SUBJECT: GENERIC LETTER 86-02, THERMAL-HYDRAULIC STABILITY
(TAC NOS. 64539 AND 64541)

RE: PEACH BOTTOM ATOMIC POWER STATION, UNIT NOS. 2 AND 3

AMENDMENT TO FACILITY OPERATING LICENSE

SAFETY EVALUATION BY THE OFFICE OF NUCLEAR REACTOR REGULATION SUPPORTING

FIGURE 3.6.5
Thermal Power And Core Flow Limits
of Specifications 3.6.F.3, 3.6.F.4 and 3.6.F.5

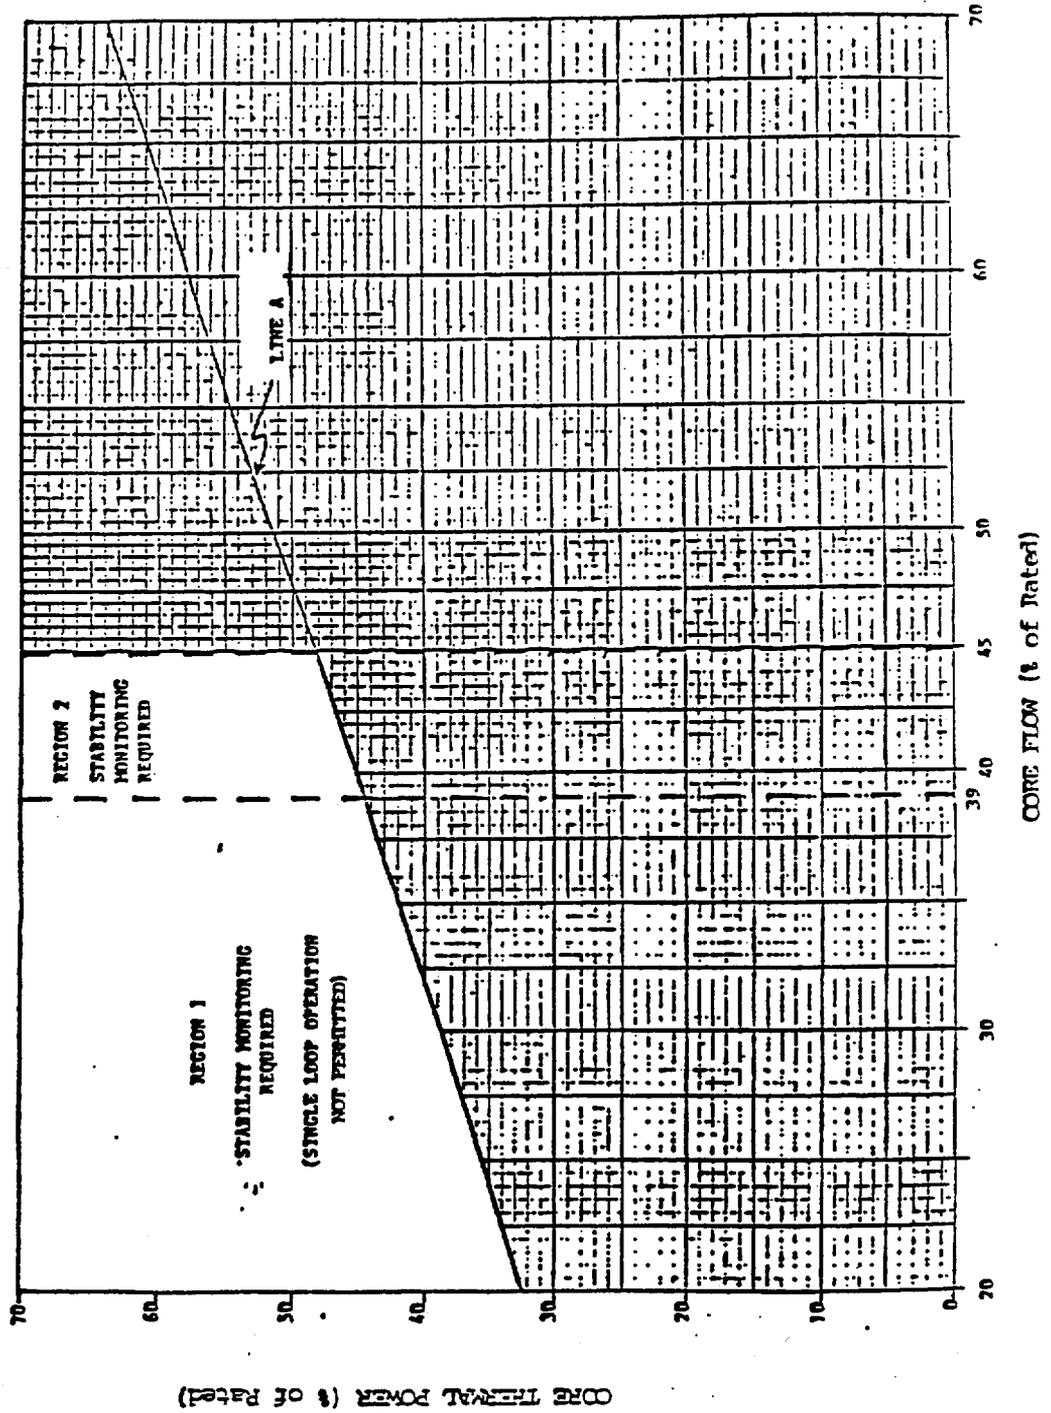
3. Whenever the reactor is in the startup or run modes, two reactor coolant system recirculation loops shall be in operation and the reactor shall not be operated in REGIONS 1 or 2 of Figure 3.6.5 (defined below), except as specified in 3.6.F.4 and 3.6.F.5

- a. REGION 1 - Total core flow less than 39% of rated and Thermal Power greater than the limit specified by Line A in Figure 3.6.5.
 - b. REGION 2 - Total core flow greater than or equal to 39% of rated, but less than or equal to 45% of rated and Thermal Power greater than the limit specified by Line A in Figure 3.6.5.

4. With only one reactor coolant system recirculation loop operating, immediately initiate action to avoid operation in REGION 1. Thermal Power shall be reduced and be below the limit specified by Line A in Figure 3.6.5 within 4 hours or core flow shall be increased to greater than or equal to 39% of rated core flow within 4 hours.

FIGURE 3.6.5
Thermal Power And Core Flow Limits
of Specifications 3.6.F.3, 3.6.F.4 and 3.6.F.5

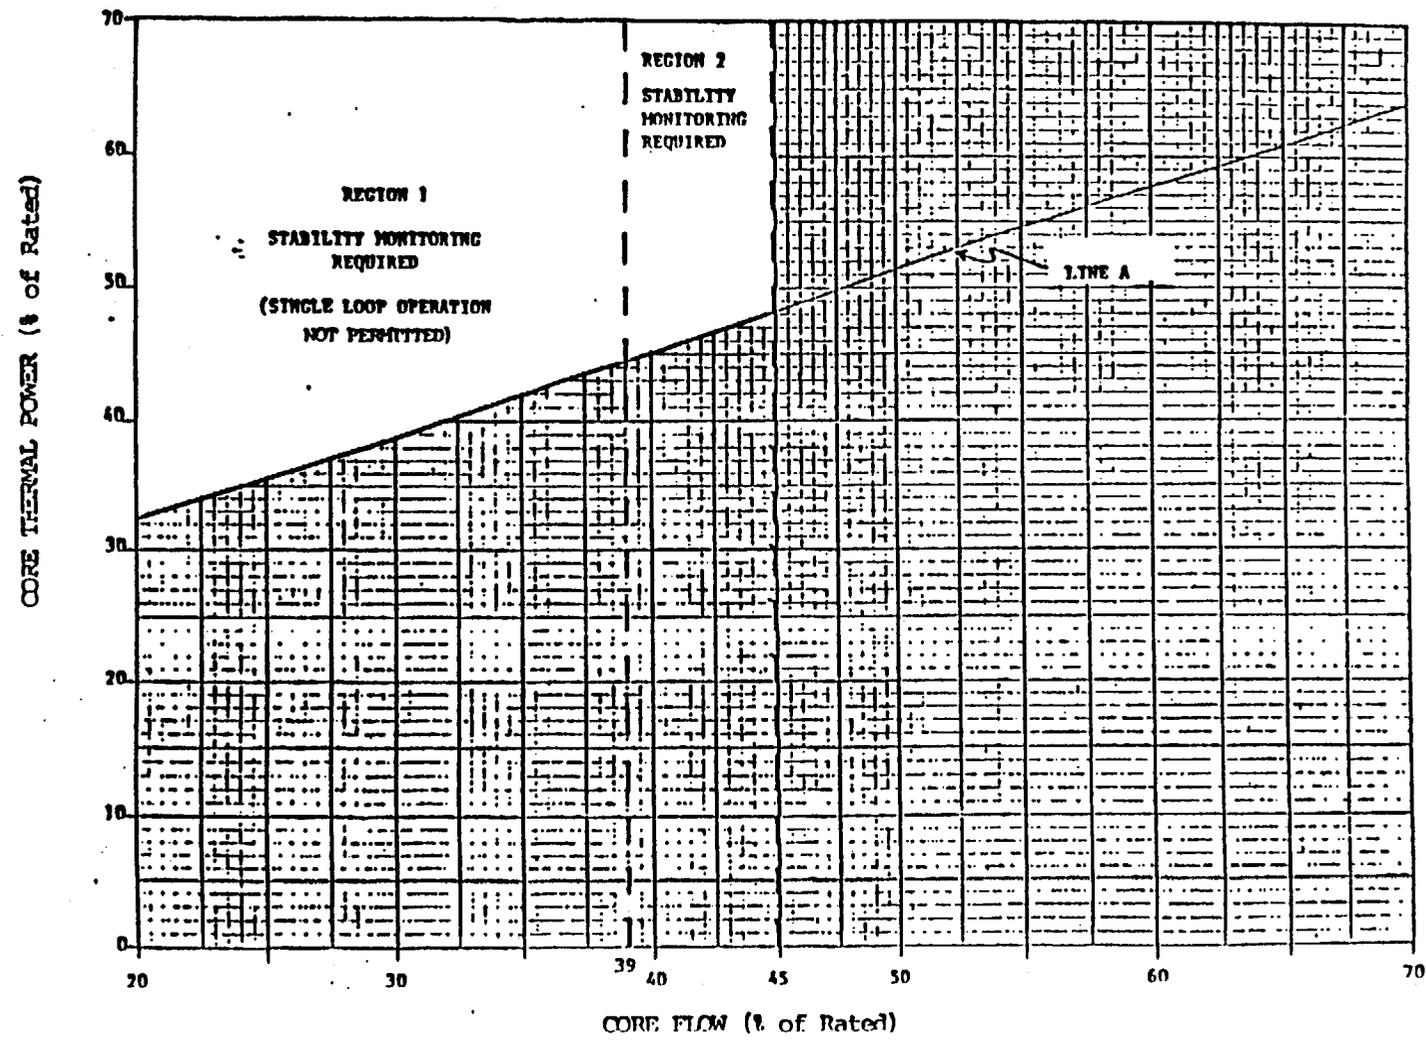
3. Whenever the reactor is in the startup or run modes, two reactor coolant system recirculation loops shall be in operation and the reactor shall not be operated in REGIONS 1 or 2 of Figure 3.6.5 (defined below), except as specified in 3.6.F.4 and 3.6.F.5

- a. REGION 1 - Total core flow less than 39% of rated and Thermal Power greater than the limit specified by Line A in Figure 3.6.5.
 - b. REGION 2 - Total core flow greater than or equal to 39% of rated, but less than or equal to 45% of rated and Thermal Power greater than the limit specified by Line A in Figure 3.6.5.

4. With only one reactor coolant system recirculation loop operating, immediately initiate action to avoid operation in REGION 1. Thermal Power shall be reduced and be below the limit specified by Line A in Figure 3.6.5 within 4 hours or core flow shall be increased to greater than or equal to 39% of rated core flow within 4 hours.

The action and surveillance regions on the power-flow map given in the Peach Bottom 3 TS 3/4.6.F and Figure 3.6.5 have been altered. These now require, above the 80 percent rod line, no operation below 39 percent flow and surveillance up to 45 percent flow. Appropriate surveillance to establish base noise levels for the relevant (specified in Ref. 4) APRM and LPRM detectors is required. Action levels requiring power or flow change to suppress oscillations are set at noise levels of four percent and three times base levels. Appropriate times or frequencies for required surveillance and suppression actions are specified. These are all in accordance with NRC current positions and recent approvals and with Peach Bottom operating experience (as called for in Ref. 4). The proposed Specifications and Bases relating to Peach Bottom 3 TS 3/4.6.F are acceptable.
